**Peer Review February 2016 of
“Akaroa Wastewater - Concept Design Report for
Alternatives to Harbour Outfall”
CH2M Beca, 29 January 2016**

**Client Consultancy Report for
Te Rūnanga o Ngāi Tahu
Report Number CP5R-16
March 2016**

Figure 4.1. Simplified diagrammatic representation of the overall wastewater management system, with DCDR options.

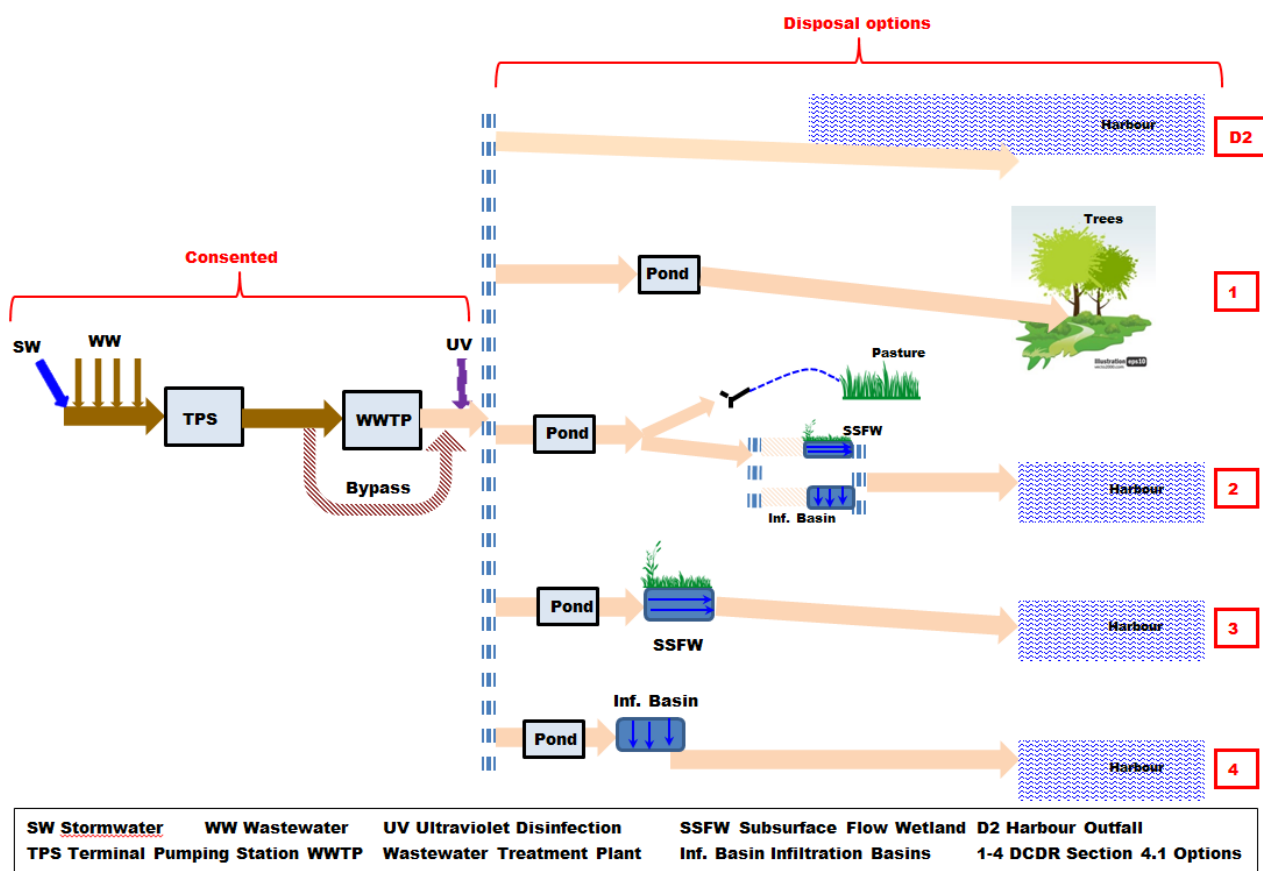
It will be helpful from this part of my review forward to present my own simplified diagram, Figure 4.1, of the overall wastewater management system, with the options included in the DCDR. It is important to note that the ‘Future Design Influent Flows’ in Table 2.1, added to in the text of s2.1.1 and s2.1.2, and illustrated as ‘SW’ and ‘WW’ in Figure 4.1, are also the ‘Future Design Effluent Flows’ which reach the receiving environments. A slight exception is the volume evaporated from the subsurface flow wetland in the ‘Winter’ alternative of Option

2 and in Option 3. The receiving environments are land under trees in Option 1, land in pasture or under trees in Option 2/Summer and the Harbour in all four other options [D2, 2/Winter, 3 and 4].

Figure 4.2. DCDR Figure 3.1 compared with a revised version based on a 7 October 2015 letter.

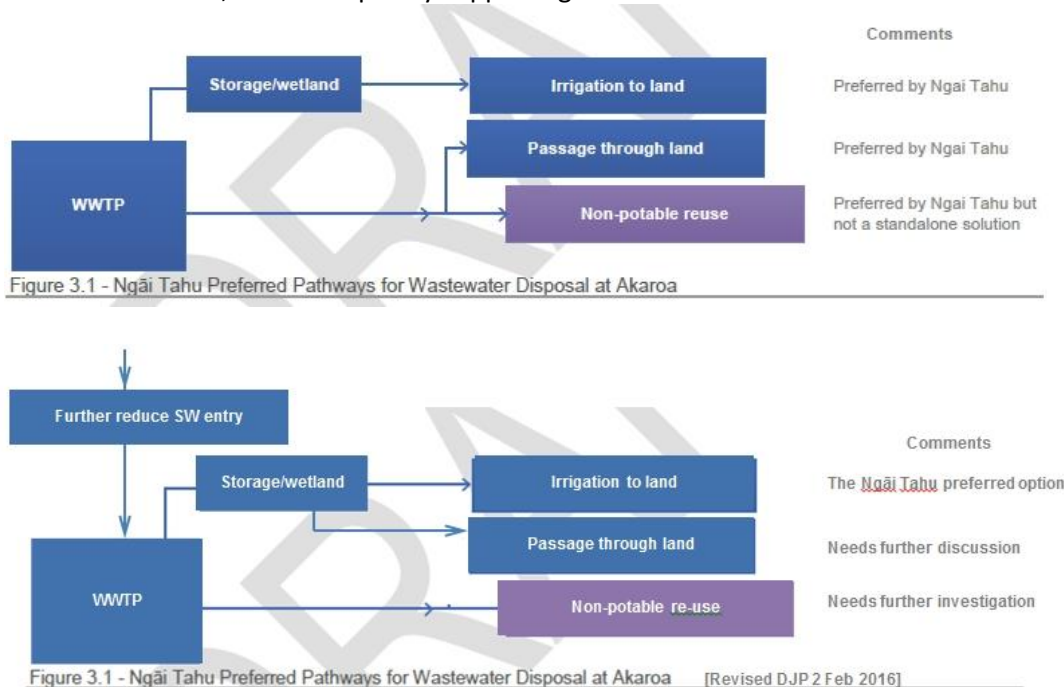
Figure 3.1 in DCDR s3.2 is intended to represent the preferred options of the Ngāi Tahu parties as conveyed in a letter dated 7 October 2015 [Appendix 2]. The figure was “was presented to and discussed with the Ngāi Tahu parties at the hui on 21 October 2015 and was agreed to represent the intention of the message they wished to convey.” [Q&A 11, Appendix 1]. My reading of the 7 October letter leads to a diagram and comments [Figure 3.1, revised DJP 2 February 2016] which are different. The two diagrams are shown in Figure 4.2. It has been confirmed on behalf of the Ngāi Tahu parties [email personal communication 3 February 2016] that my “interpretation is correct”. The further explanation is that ‘passage through land’ [as a proposed specific engineering solution, rather than the principle] was first put forward in a presentation on 8 September 2015 with “very little information about how it would work”. The 7 October 2015 letter intended to “keep it on the table requesting further information, but not explicitly supporting it.”

The two primary differences between the two different portrayals are:

1. The revised comments clarify that 'Irrigation to land' is the preferred option. 'Passage through land' was not 'preferred' at that time, in part because the Ngāi Tahu parties did not then know enough about it.
2. The revised diagram includes the need to "Further reduce SW entry". [See also Point 2, under Figure 4.1 in Section 4.2 above.]

6. Figure 3.1 in the Concept Design Report does not accurately represent the preferred options of the Ngāi Tahu parties as conveyed in a letter dated 7 October 2015. It should recognise that Irrigation to Land is the preferred option, stormwater entry should be further reduced, passage through land needs further discussion and non-potable reuse needs further investigation. [4.3]

6.	Figure 3.1 in the Concept Design Report does not accurately represent the preferred options of the Ngāi Tahu parties as conveyed in a letter dated 7 October 2015. It should recognise that Irrigation to Land is the preferred option, stormwater entry should be further reduced, passage through land needs further discussion and non-potable reuse needs further investigation [4.3].	The figure has been updated.
